Service Bulletin

FEBRUARY

NO. 351

Studebaker

FIG. 1

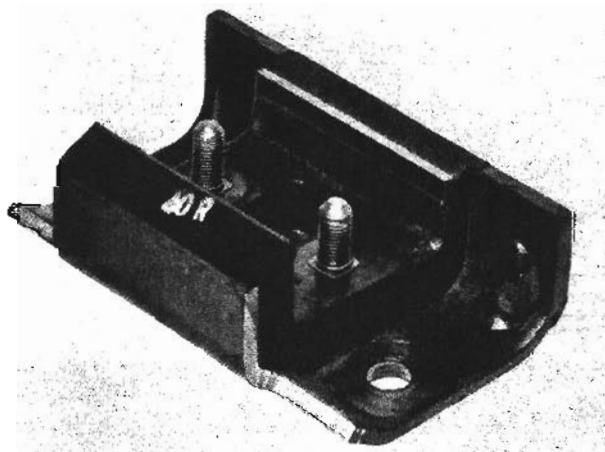
CLUTCH REMOVAL - Y1 Models

When removing and replacing the clutch on models equipped with Engine Rear Support Insulator, Part No. 1550063 (see Fig 1), it is not necessary to remove the crossmember.

To remove the clutch assembly, remove the two nuts and washers holding the insulator to the crossmember. Remove the two cap screws holding the insulator to the clutch housing. Raise the engine and slide the insulator forward and remove it from the crossmember. Push the clutch housing to the rear and rotate until the starter area is adjacent to the crossmember. Remove the pressure plate assembly from the flywheel. Then, the driven plate can readily be removed. To remove the pressure plate assembly, move it toward the starter area in the clutch housing and slip it out from between the clutch housing and engine rear plate. To install, reverse the procedure.

This new type rear support insulator, can be used on all S-Y1 Models.

FIG. 2

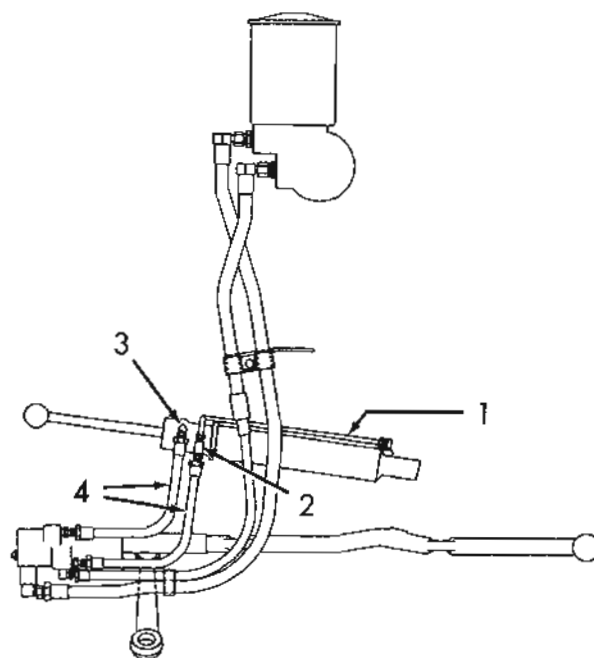
POWER STEERING CYLINDER ASSEMBLIES - Packard

When the supply of Power Steering Power Cylinder Assembly, Part No. 455211, is exhausted, it will be superseded by Power Cylinder Assembly, Part No. 443701.

To accommodate the installation of Power Cylinder 443701 as a replacement for 455211, the following parts will be included with Part No. 443701:

1. TUBE, 2. TEE FITTING, 3. ELBOW, 4. HOSE

In line with the assembly substitution, Power Cylinder Tube and Ball Stud Assembly, Part No. 436470, will be substituted for Power Cylinder and Ball Stud Assembly, Part No. 458216, when the supply of Part No. 458216 is exhausted. When the Part No. 436470 is supplied, the Connector Fitting, Part No. G-442321, will be included.
